DEVIATION REQUEST AND DECISION FORM

Project Name : Eagleview Subdivision
 Schedule No.(s) : 5226000001), 5226000001)
 Legal Description : N2NW4 EX WLY 620.0 FT SEC 26-12-65,S2NW4 EX WLY 620.0 FT SEC 26-12-65

Deviation No. 4

Exhibit 1

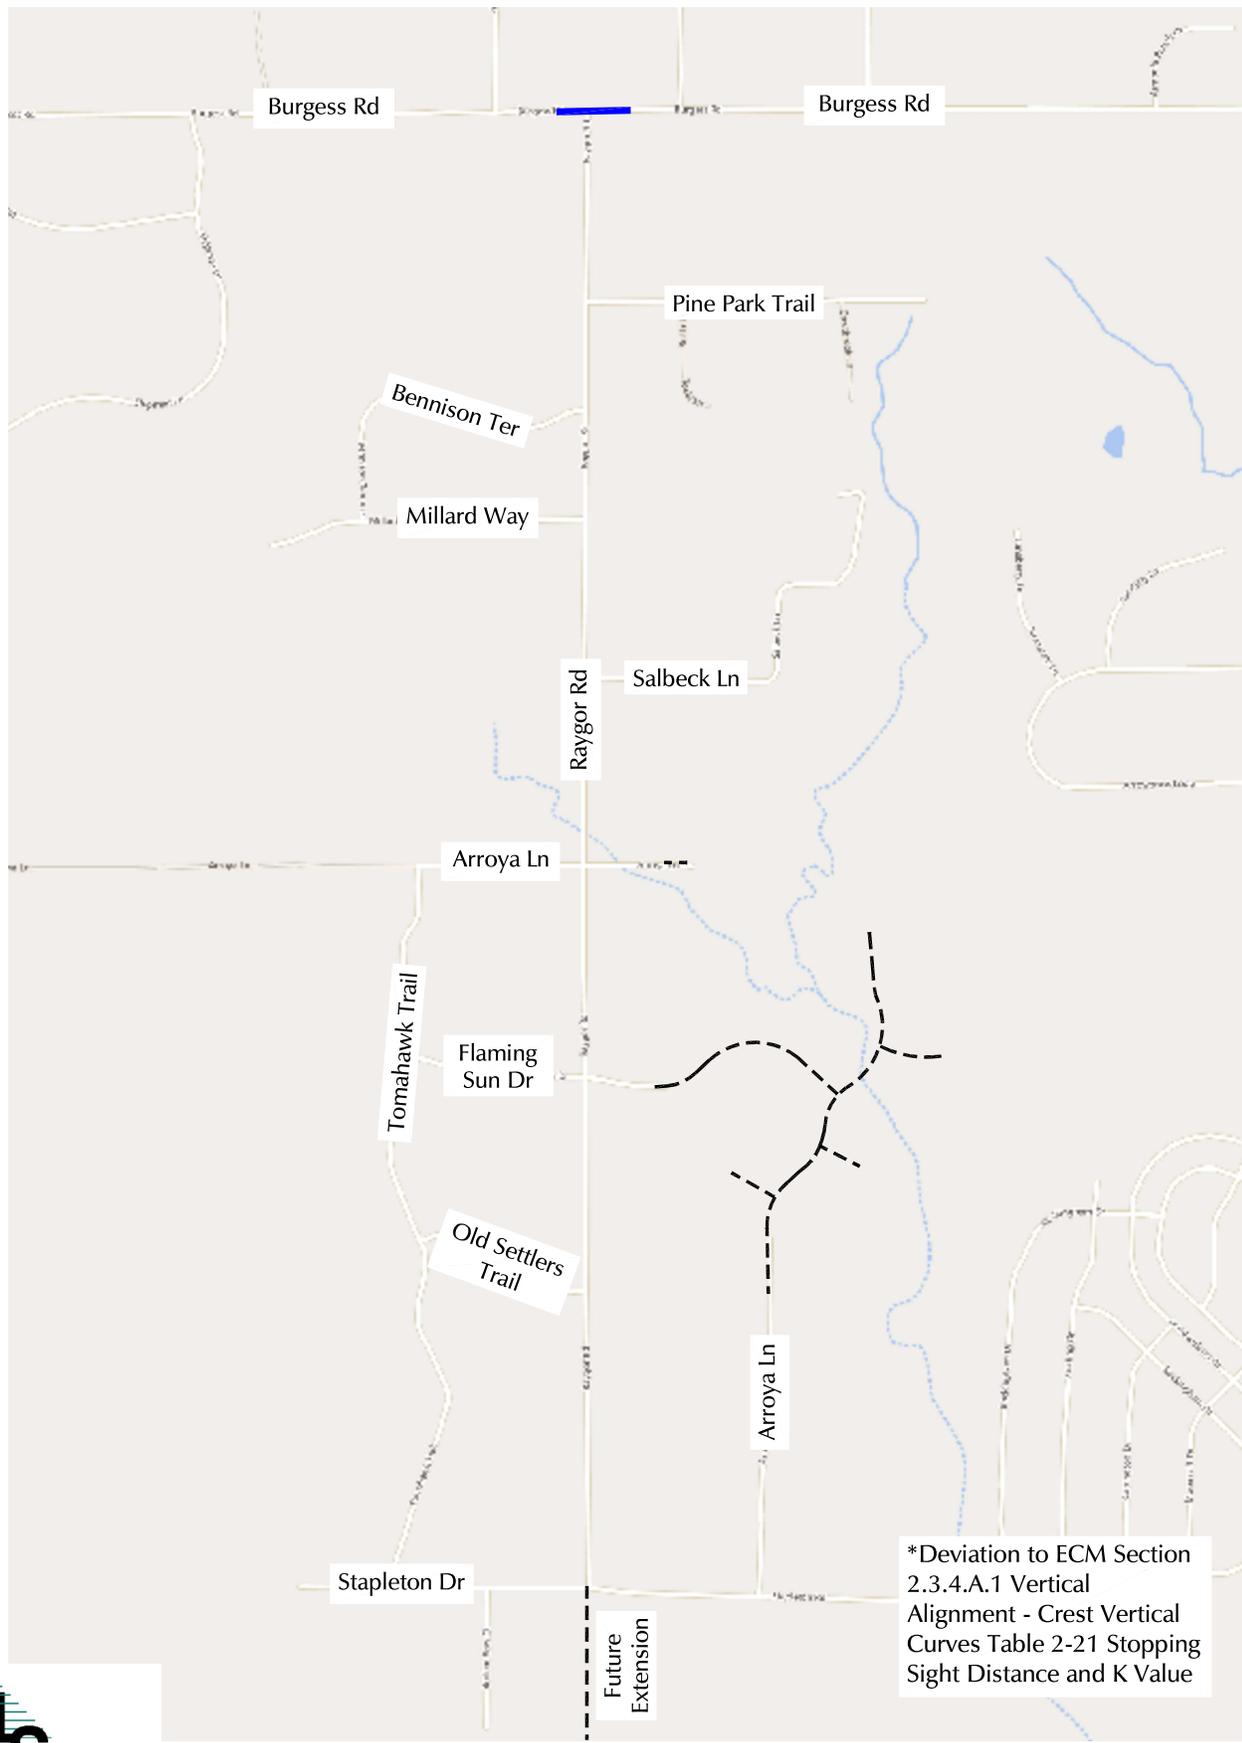
Include 2.3.6.G
Intersection sight
distance.

Burgess is classified
as a minor arterial.
Update design speed
to 60 mph.

Deviation Exhibit 2

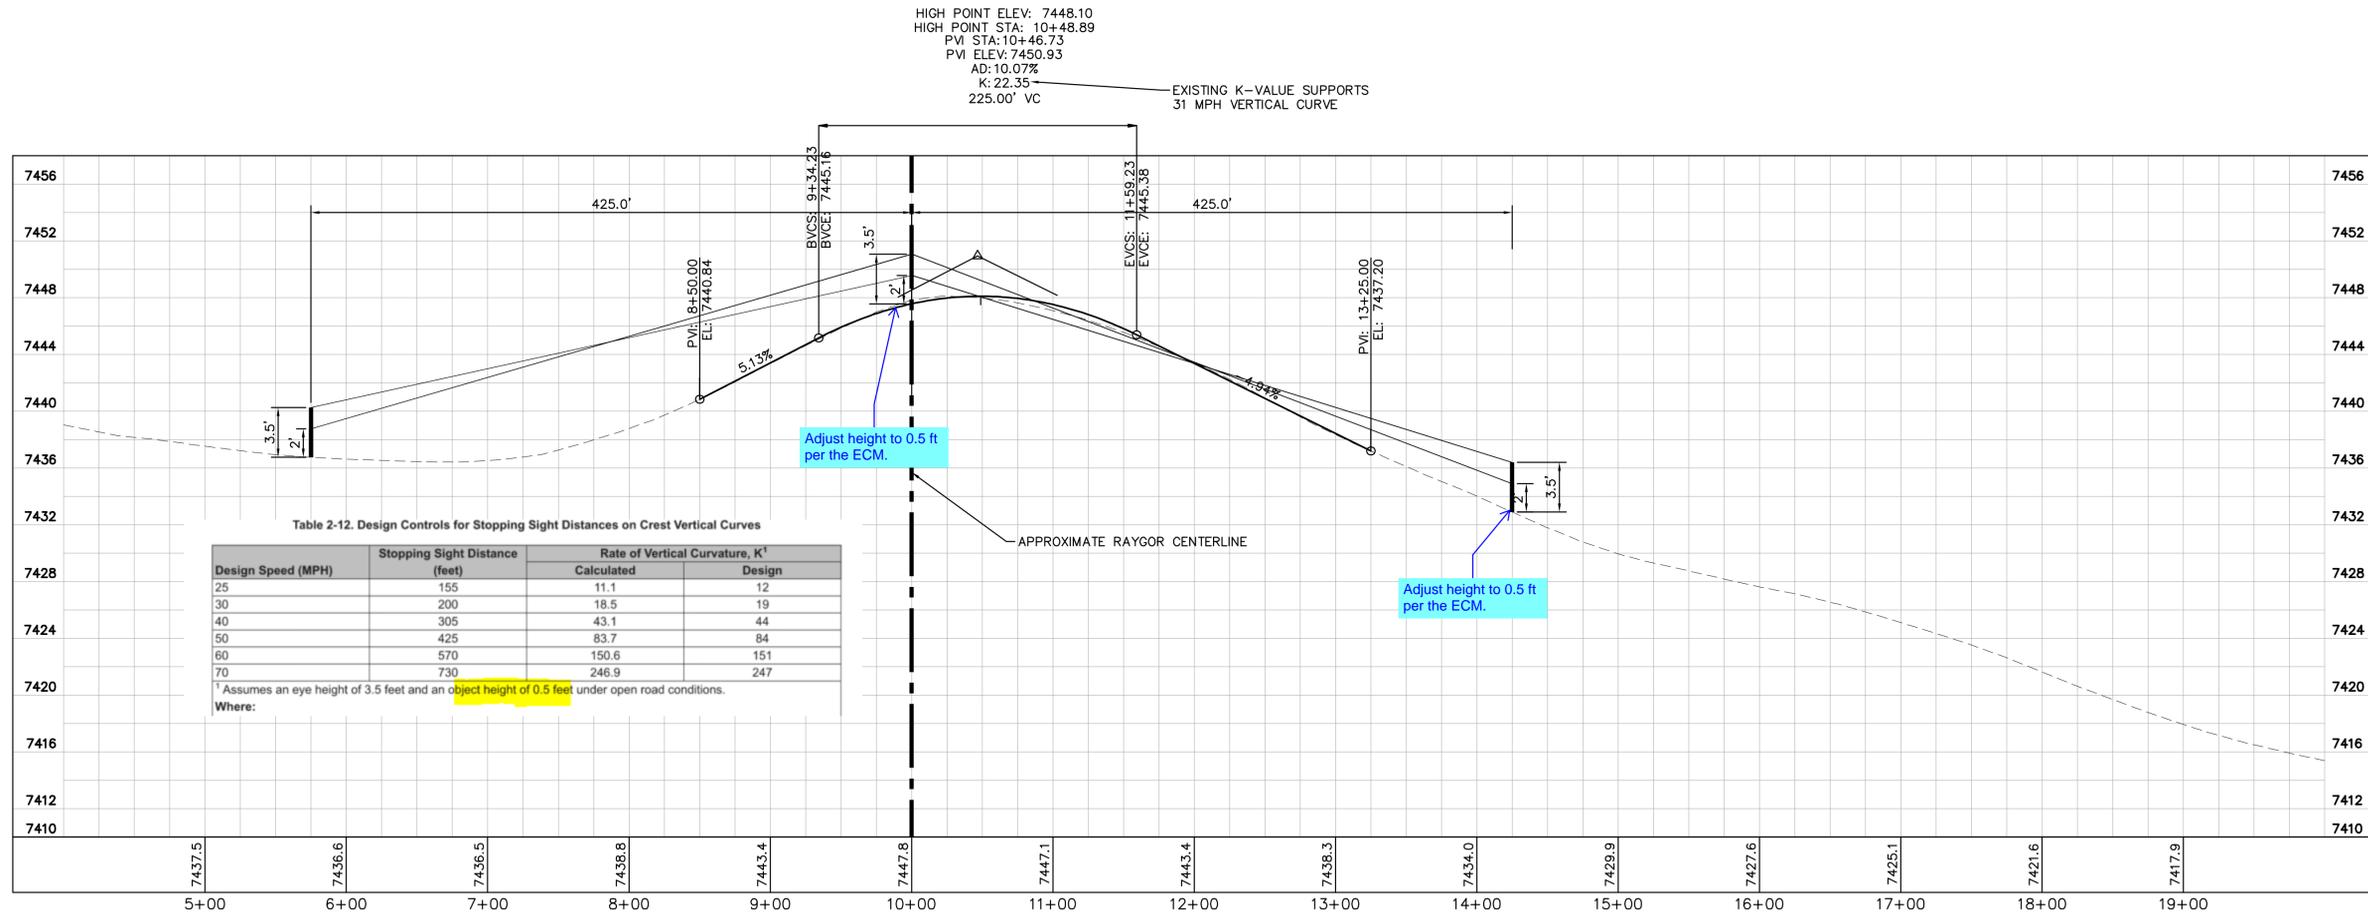
Provide a profile exhibit of the intersection sight distance.
